**City of Portland, Maine - Building or Use Permit Application**  
 389 Congress Street, 04101 Tel: (207) 874-8703, Fax: (207) 874-8716

Proposed Project Description:  
Build 8' X 10' Addition for Mudroom

LOADING PERMIT REPORT

REASON FOR PERMIT: To Construct a 8' x 10' addition

PAIGE RESIDENCE  
 PLOT PLAN  
 SCALE: 1" = 13'

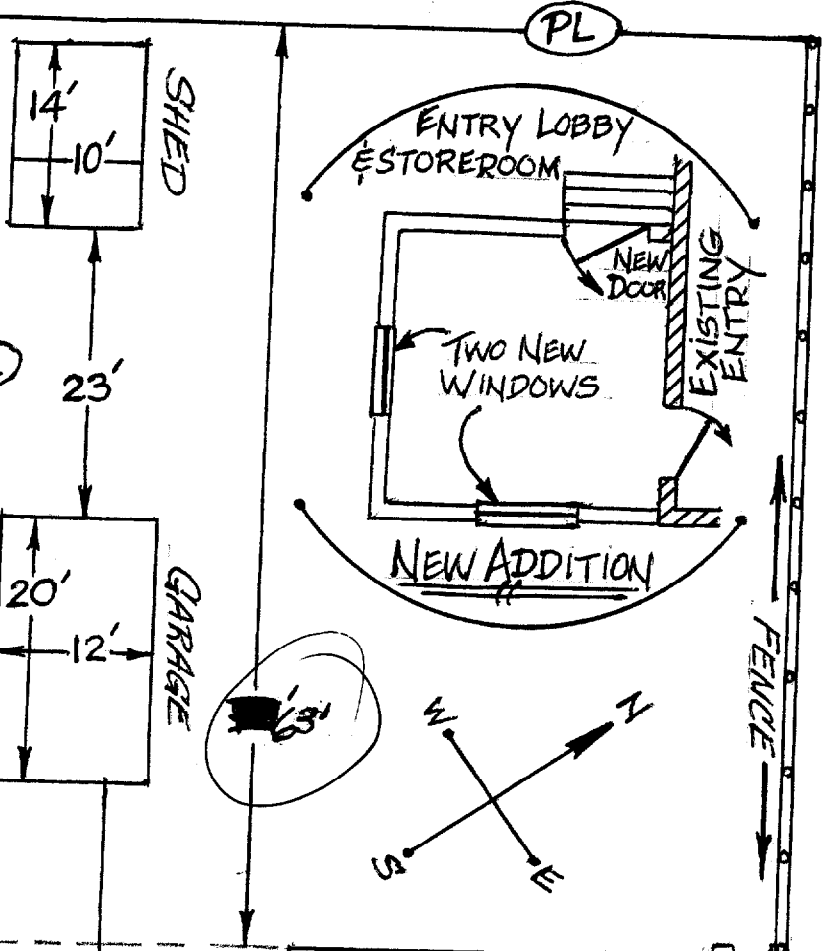
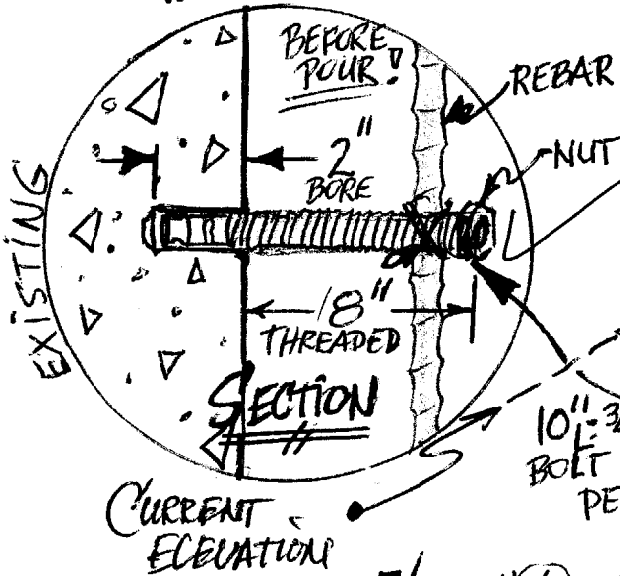
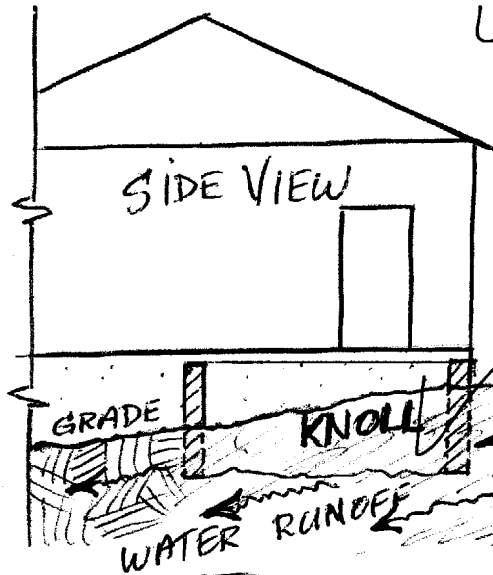
2-3 Zone  
 Front: 25' req - 26' shown  
 Rear: 25' req - 63' shown  
 side: 8' req - 15' deduced

26' required from the property line not sidewalk unless the side wall is the property line
